TOSC Review of Pall Life Sciences
***“Final Feasibility Study & Proposed Interim Response Plan for
the Unit E Plume”***

By: Lawrence D. Lemke, Ph.D.
Environmental Sciences Program
Department of Geology
Wayne State University
Detroit, MI 48202

Date: August 4, 2004

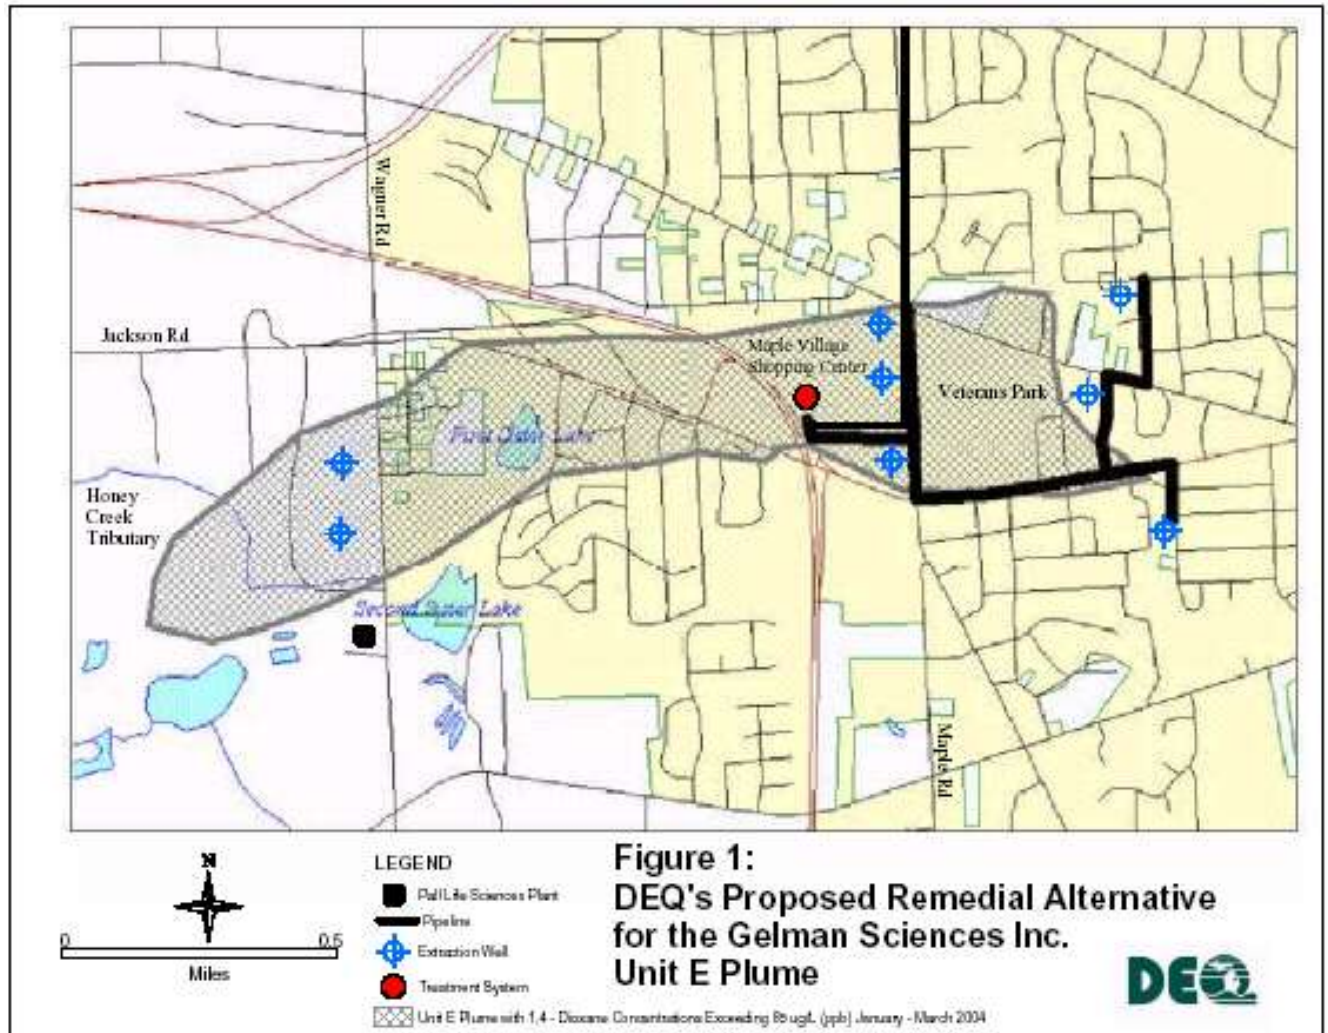
The E Plume, a body of groundwater contaminated by 1,4-dioxane stretching from the PLS facility located on Wagner Road to a location east of Maple Road in western Ann Arbor, is thought to be migrating eastward through a glacial aquifer system. Complex hydrogeologic conditions, gaps in subsurface data, and lack of a comprehensive groundwater model impede the ability to predict the plume’s migration path and formulate specific remediation plans. (The area known to be affected by the E Plume is illustrated in Figure 1 at the end of this document.)

Consequently, the MDEQ has proposed a remedial alternative combining groundwater extraction at the leading edge of the plume **in combination with** Interim Response measures at Maple Road and Wagner Road. This approach is designed to separate the E plume into three segments and remove 1,4-dioxane at the downgradient edge of each, thus taking advantage of the natural direction of contaminant transport while accelerating the cleanup. Groundwater pumped from Wagner Road extraction wells would be treated on site at PLS and discharged into the Honey Creek tributary under the existing discharge permit. Groundwater extracted from Maple Road would be decontaminated in a treatment system located in the same area and disposed of using surface water
